Overheating – 3 Litre

MERCURY AND MARINER

1994 thru 1996, 225/250 HP, 3.0 Litre
S/N 0D280813 thru S/N 0G437999

1997 200 HP DFI
S/N 0G386496 thru 0G509800

a - Drain hole drive shaft housing (one each side)

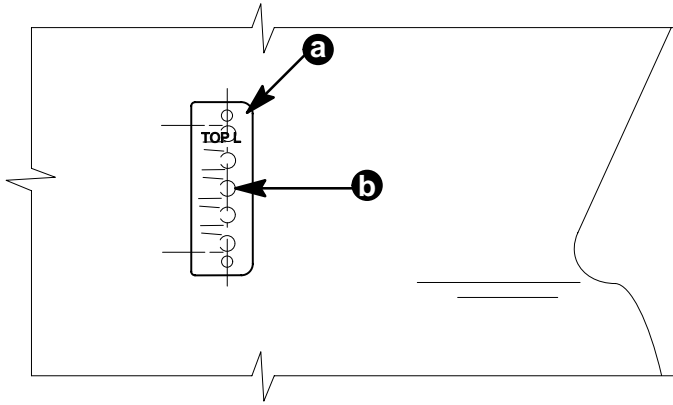
If the overheating condition continues after the above items have been checked, restrict the drive shaft housing drain holes as outlined, using a 1/16 inch pipe plug P/N 22-56800.

1. Cut threads into the drive shaft housing drain holes located on each side of the lower unit, using a tapered 1/16 inch 27 NPTF pipe tap.
2. Apply Loctite #271 (P/N 92-809820) to the threads of plug P/N 22-56800.
3. Install plug P/N 22-56800 so head of plug is even/flush with the surface of gear housing.
4. Drill a 1/8 inch (3.17mm) hole through the center of the plugs.
5. Paint over the plug with touch-up paint.

NOTE: The two drilled plugs will restrict the water that will exit the drive shaft housing. This will insure that proper water level is maintained above the water pump, preventing air from being drawn into the cooling system through the water pump.
